**VENTURA UNIFIED SCHOOL DISTRICT
BUENA HIGH SCHOOL STADIUM SURFACING**

BID # E15-25

ADDENDUM #01

Bid Addendum No. A
To the contract documents for BUENA HIGH SCHOOL TRACK AND FIELD REPLACEMENT
For the VENTURA UNIFIED SCHOOL DISTRICT

DEMOLITION & EROSION CONTROL PLAN

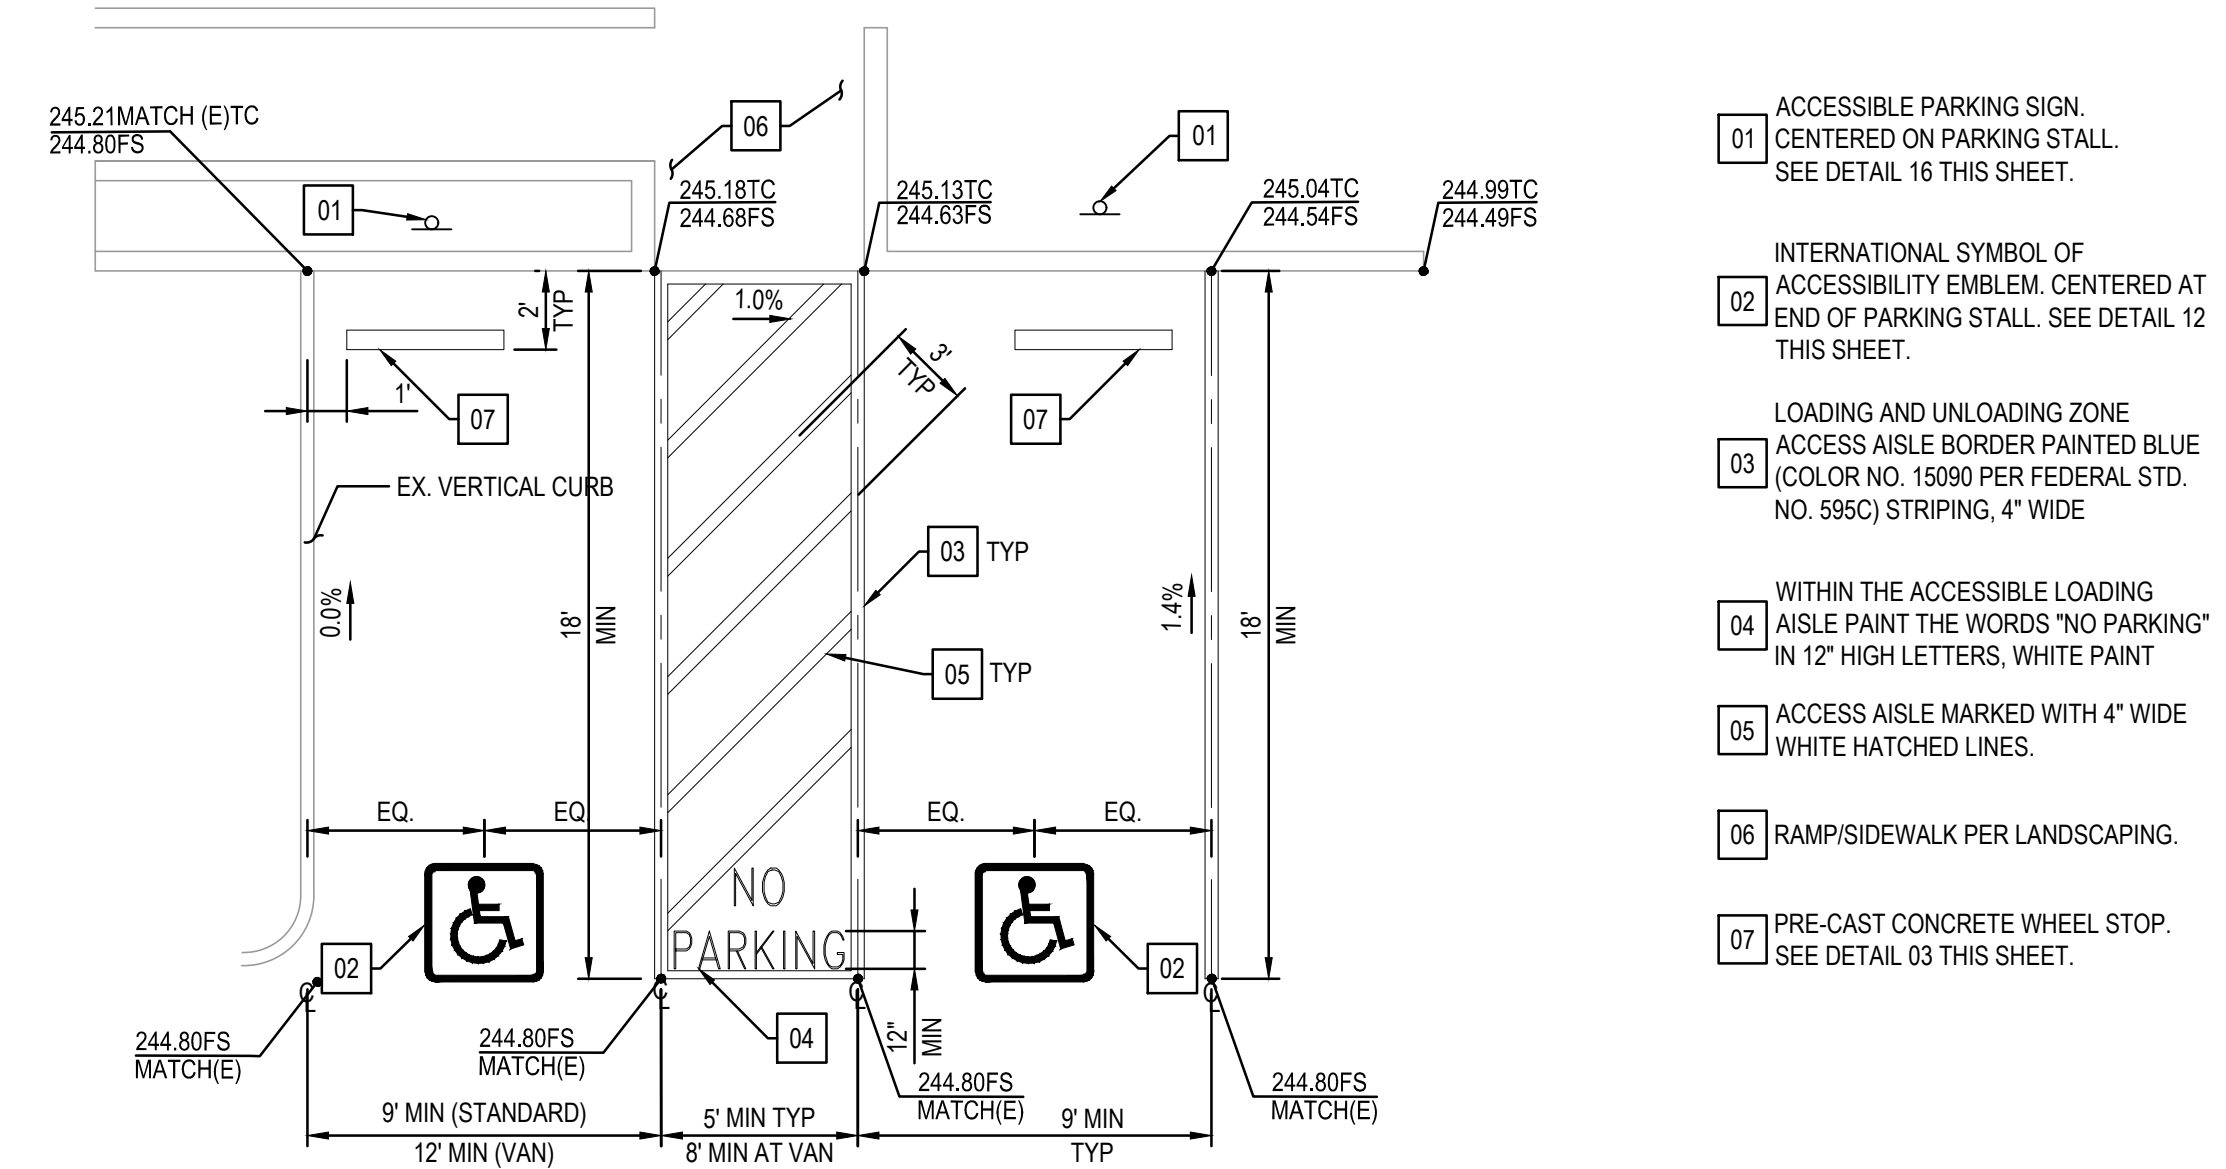
- Item No. 1** **C1.01 – DEMOLITION & EROSION CONTROL PLAN** – Removed portion of existing pavement in the track and patch in place. Removed and replaced concrete.

C2.01

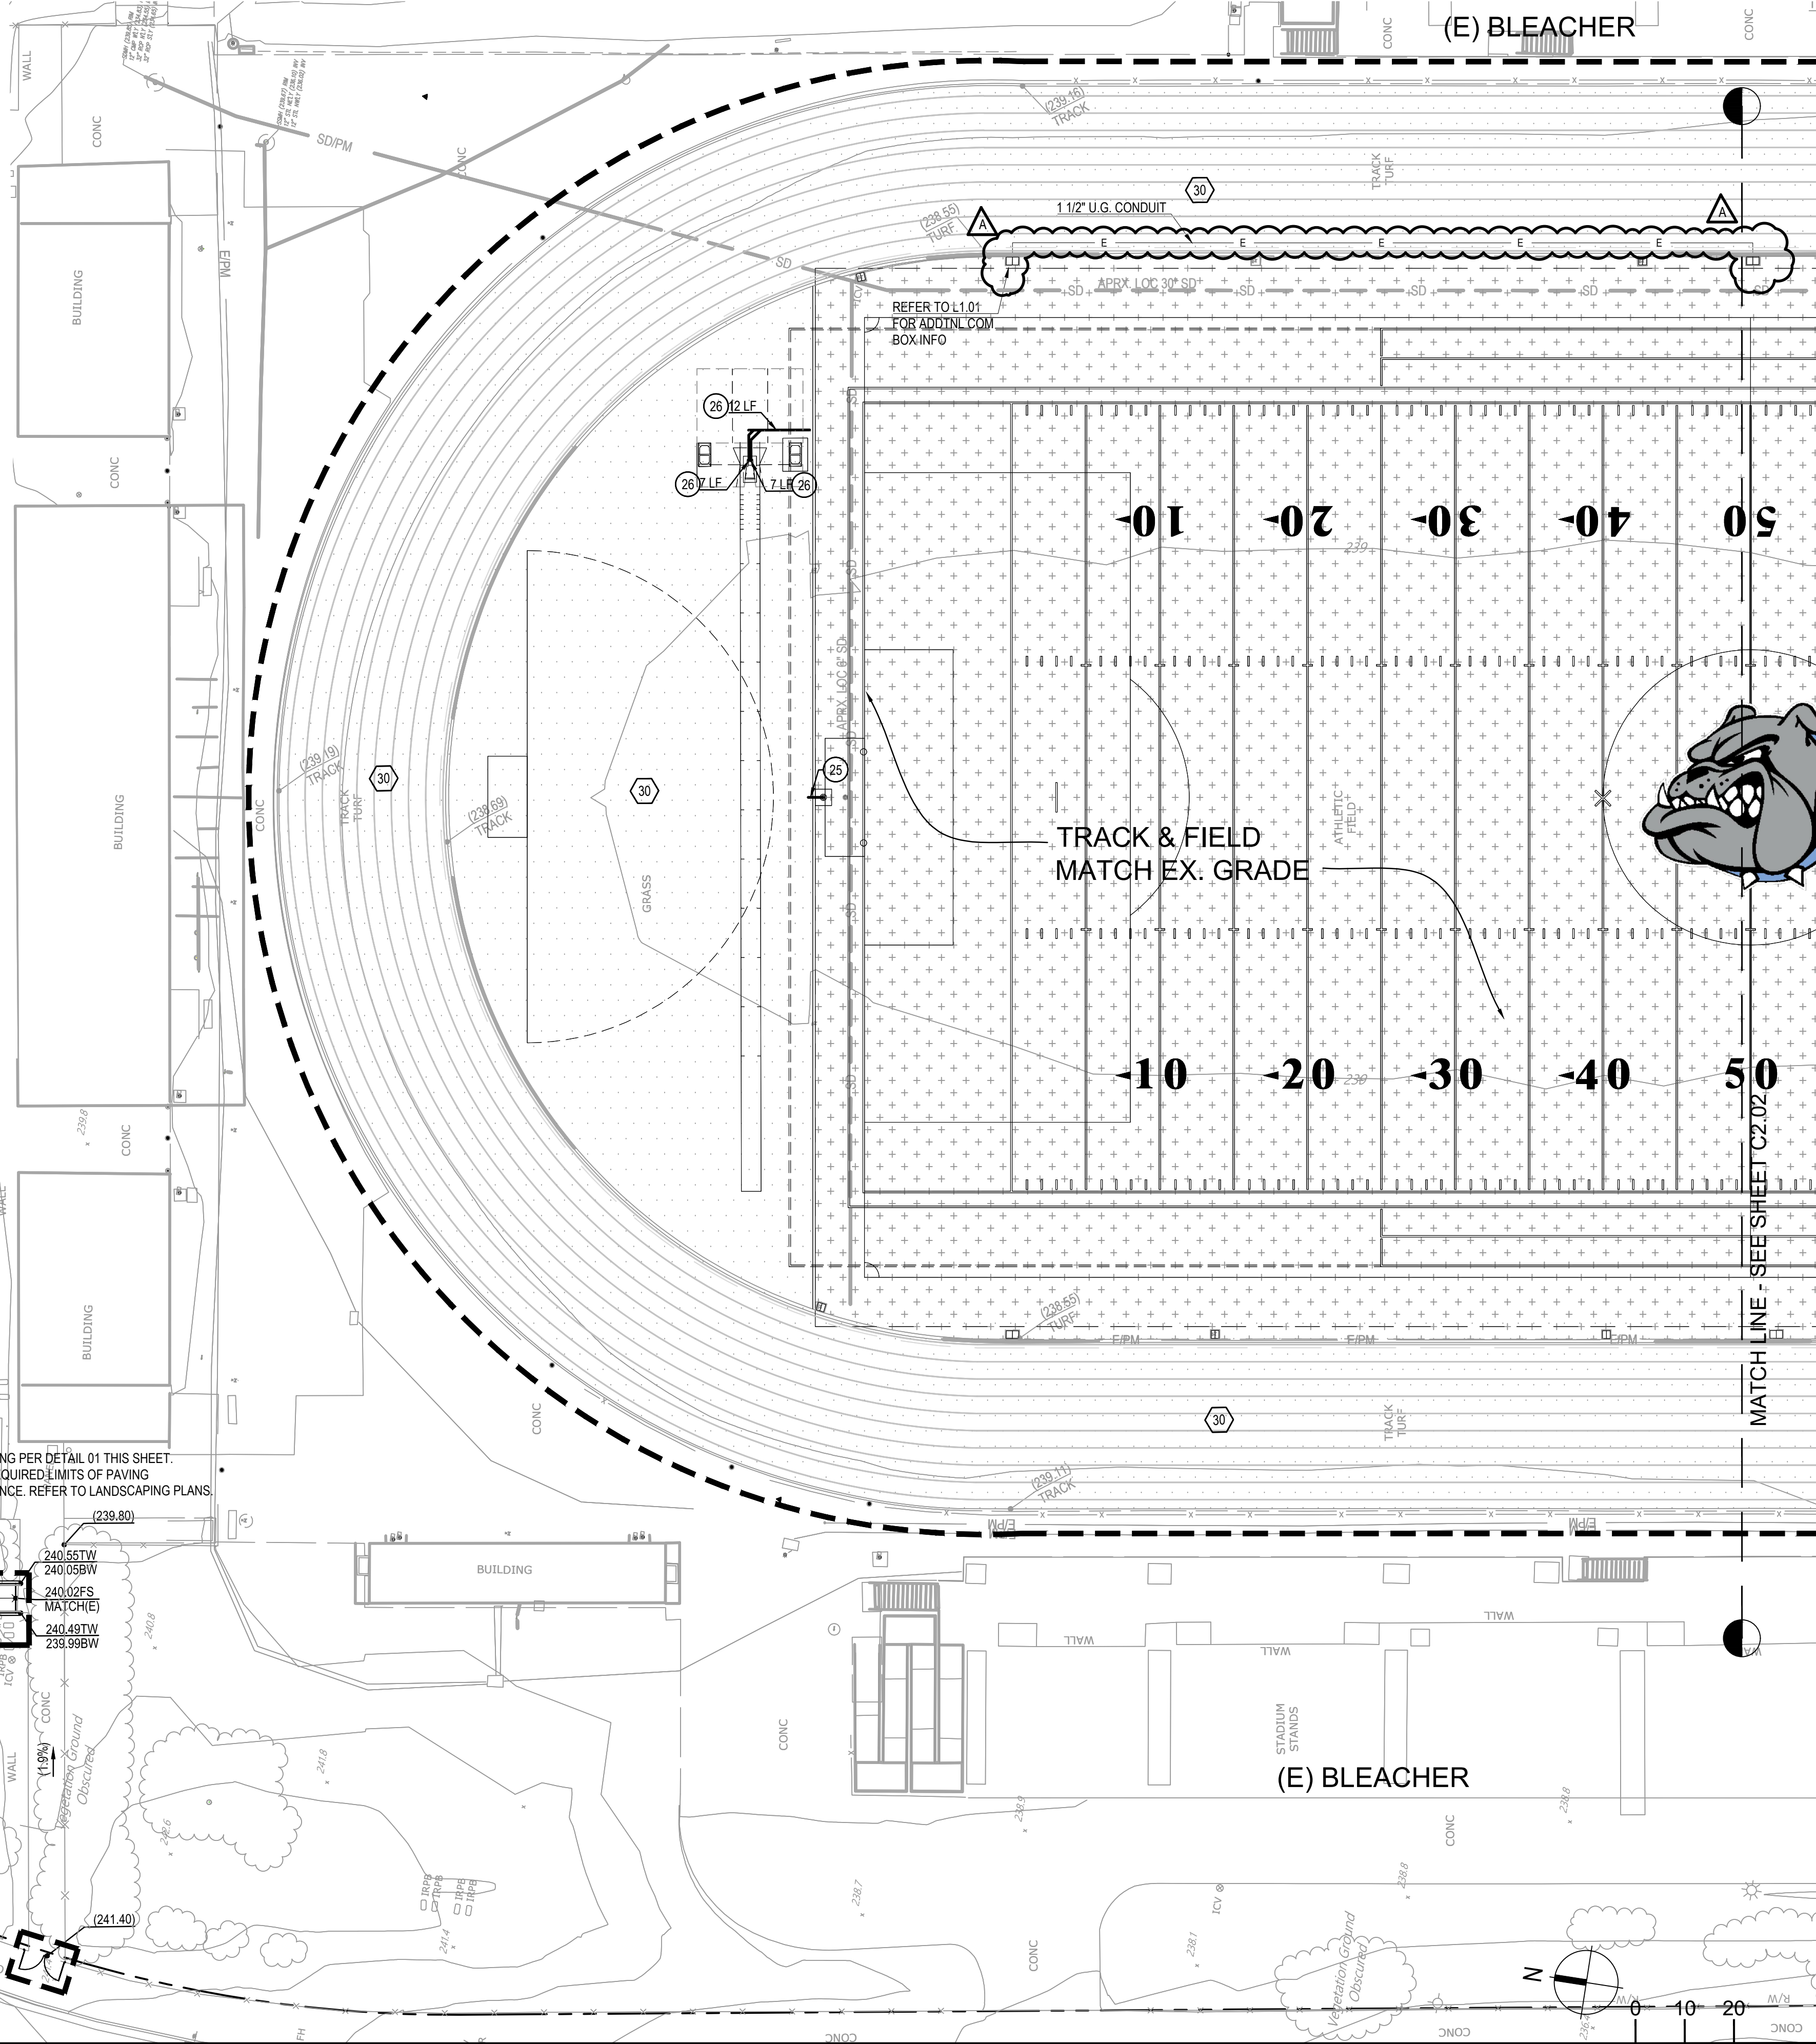
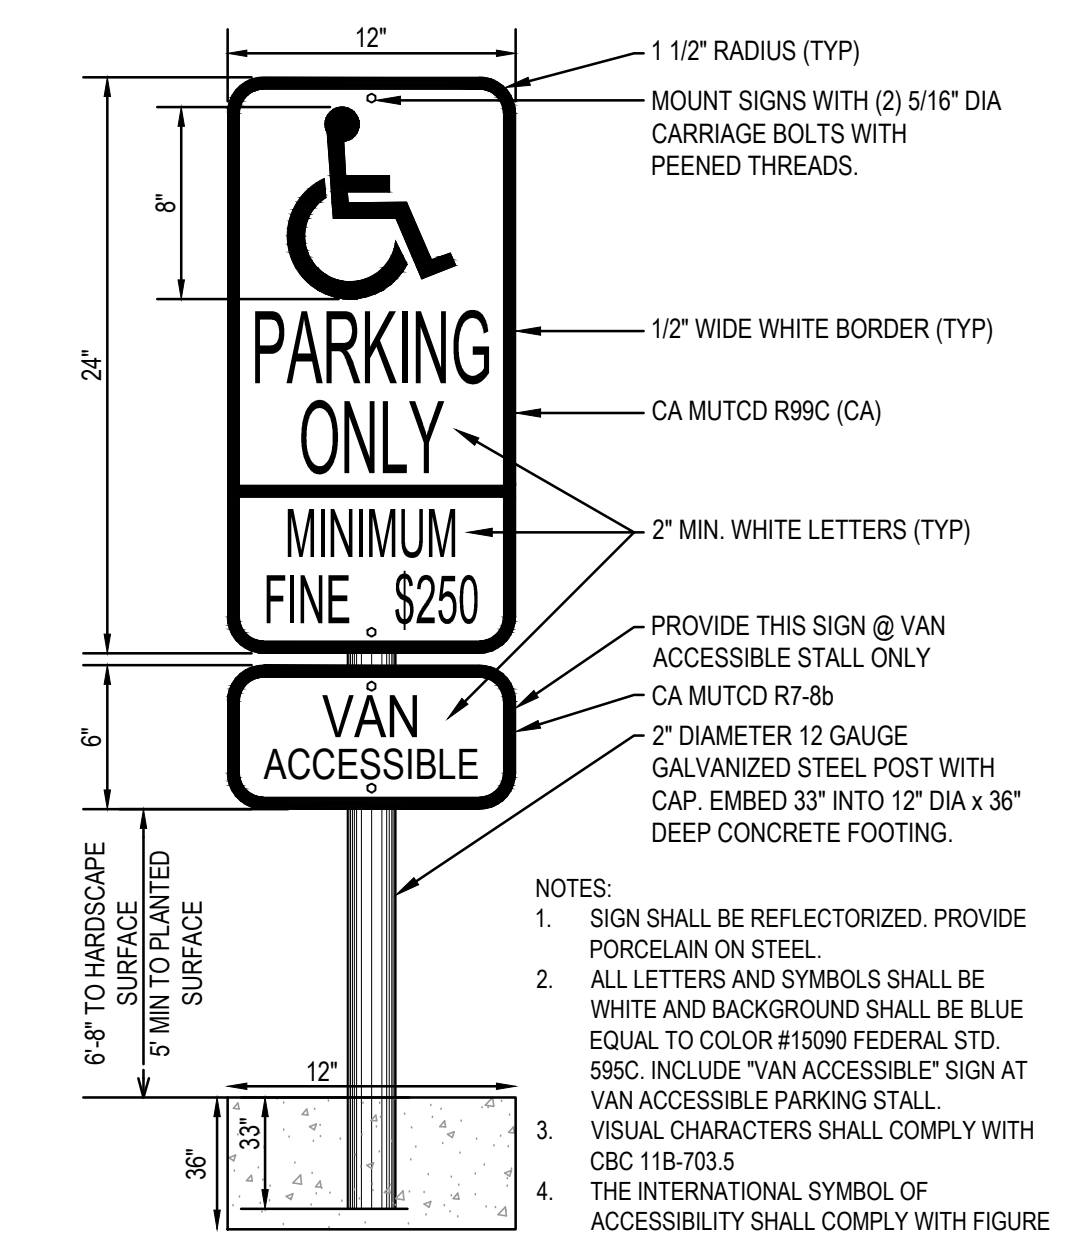
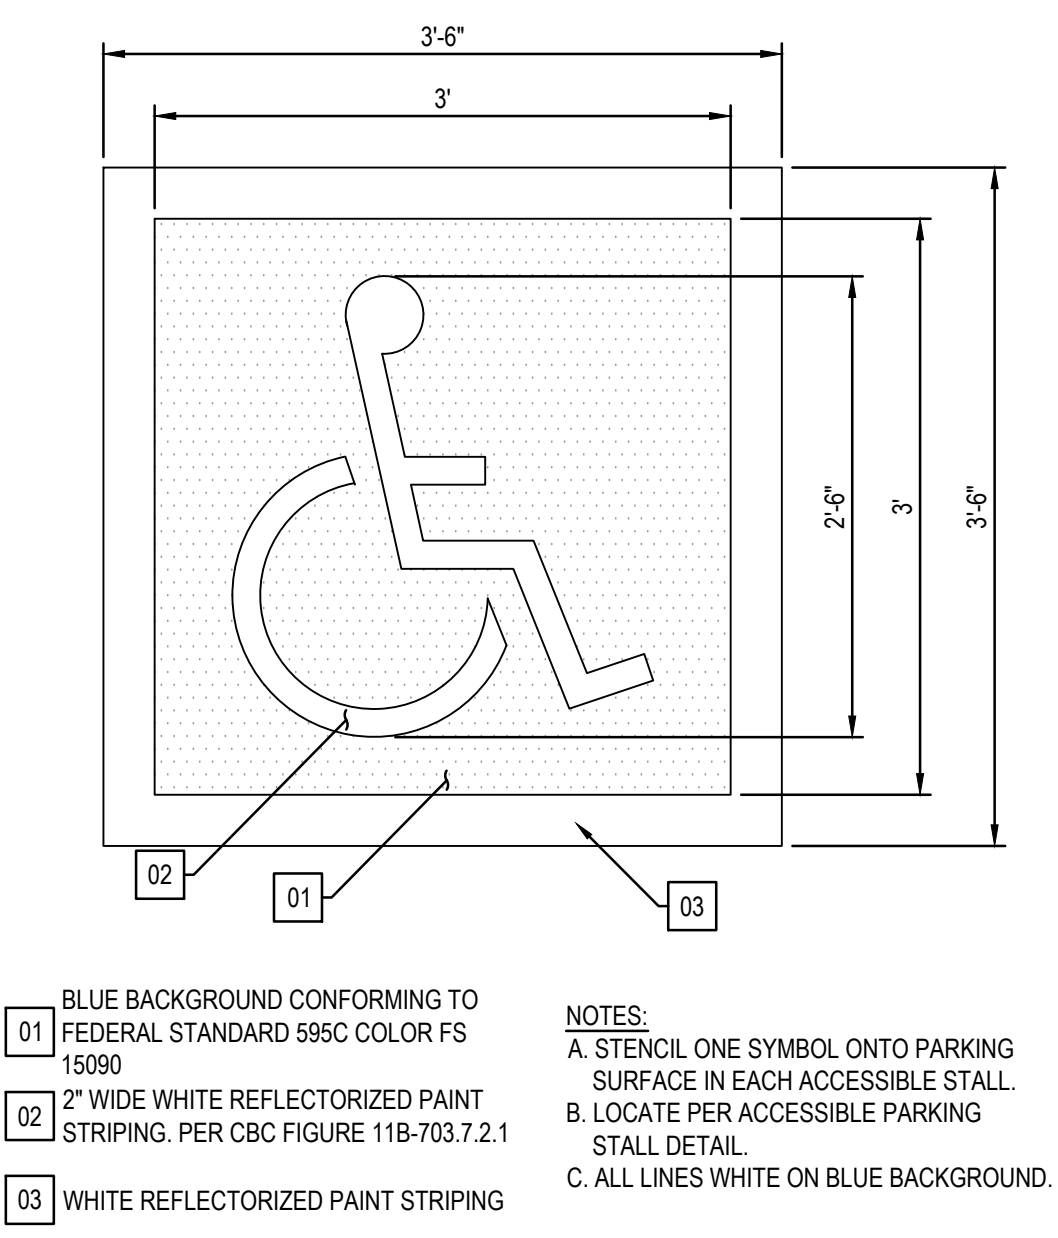
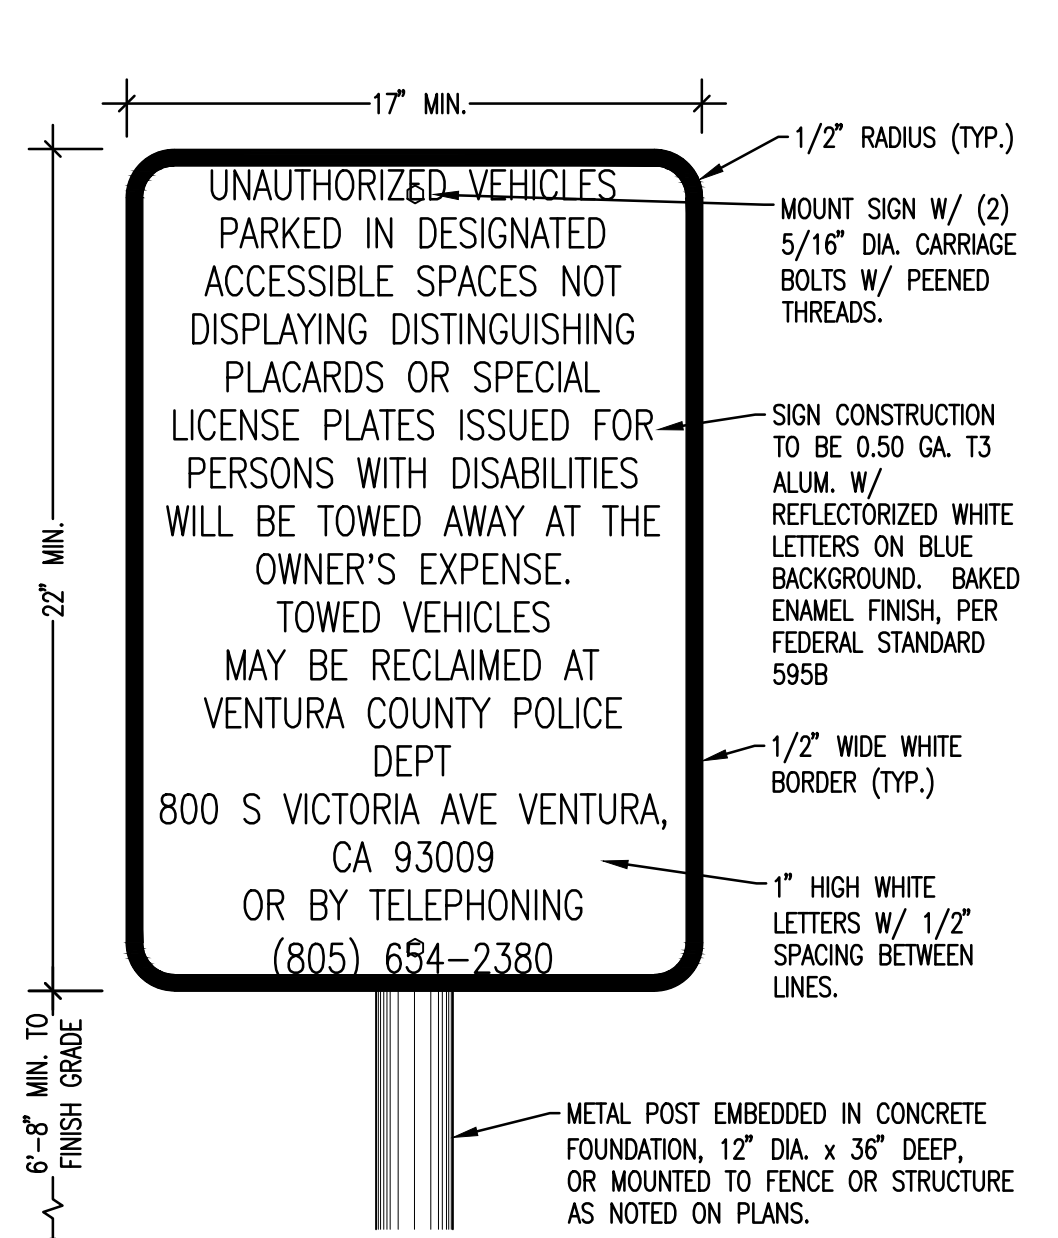
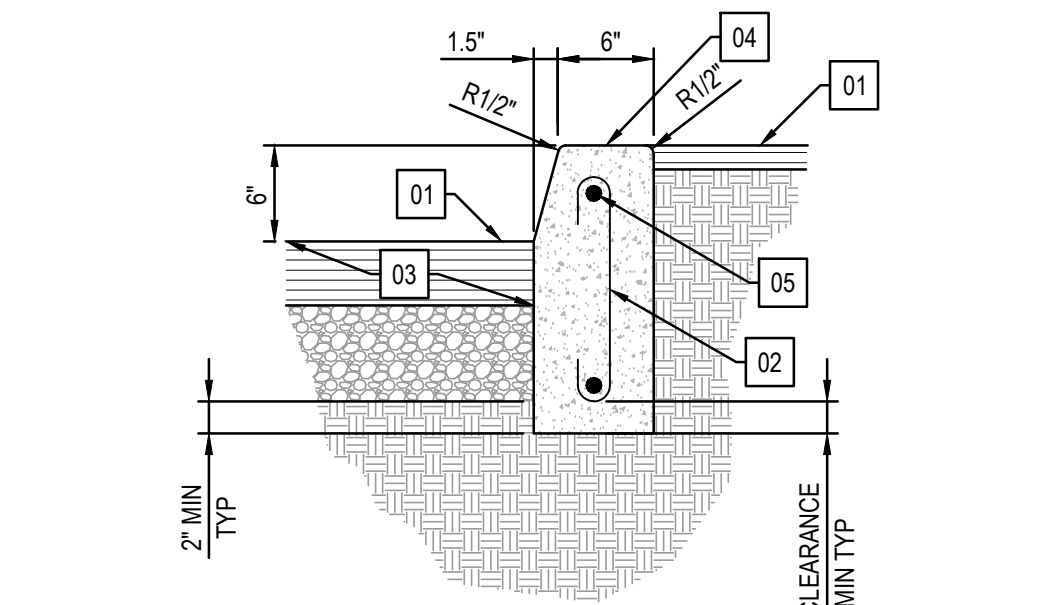
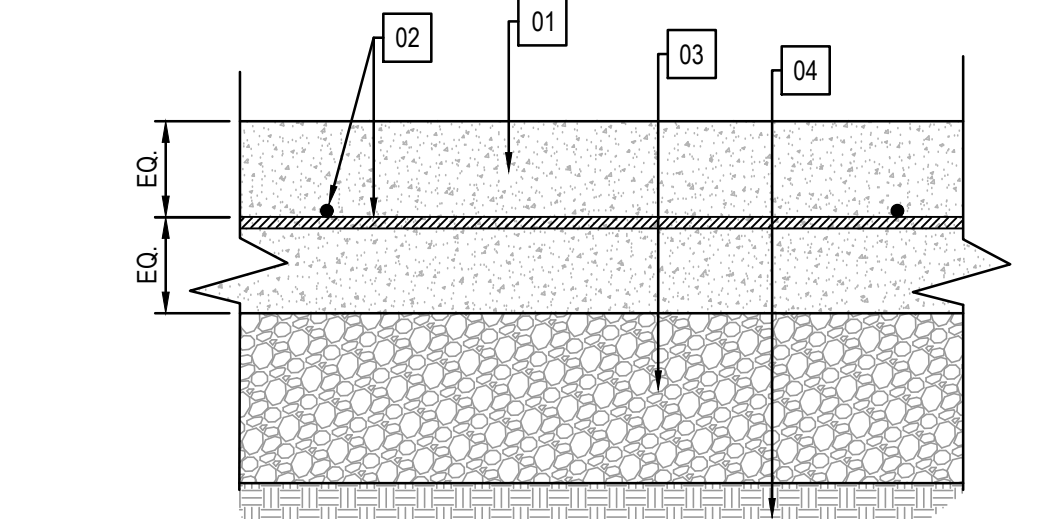
- Item No. 2** **C2.01 – GRADING, PAVING, STORM DRAIN & DETAILS PLAN:** Provide connection to existing comm box and supply 1 ½” underground conduit and new com box.
